Trust in water

Economic value of bioresources assets – feedback to companies

This document sets out feedback to the ten largest water and sewerage companies in England and Wales (companies) on their assessments of the value of their bioresources assets that each company submitted in September 2017.

Figure 8.1 Comparison of economic value and proposed RCV allocation

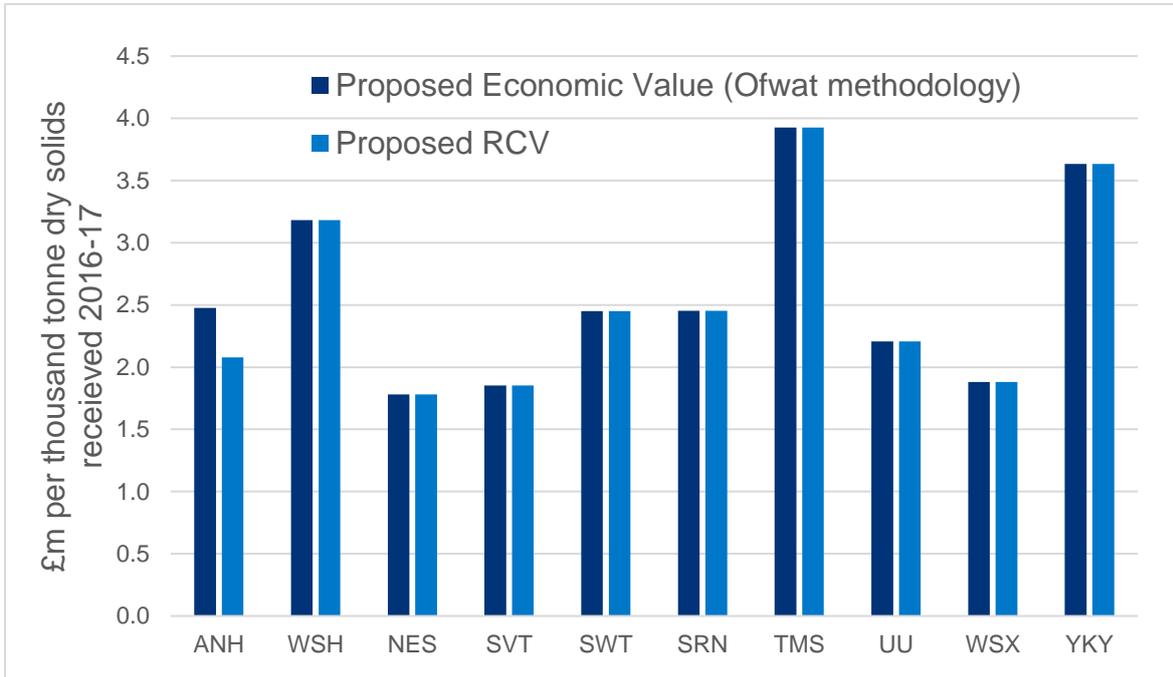
8.5 Figure 8.1 sets out companies' proposed RCV allocations to the bioresources control and how they compare to economic value.

- 8.8 Companies may propose to allocate the RCV based on an economic value that includes a proportional allocation of shared assets or excludes shared assets for which the bioresource business unit is not the principal user. We will consider company business plan submissions and propose a consistent approach in our PR19 draft determinations. Companies' inclusion (or exclusion) of a proportionate allocation of shared assets for which the bioresource business unit is not the principal user in their proposed RCV allocation will not negatively affect our initial assessment of plans as long as a company sets out a considered view to support its decision.
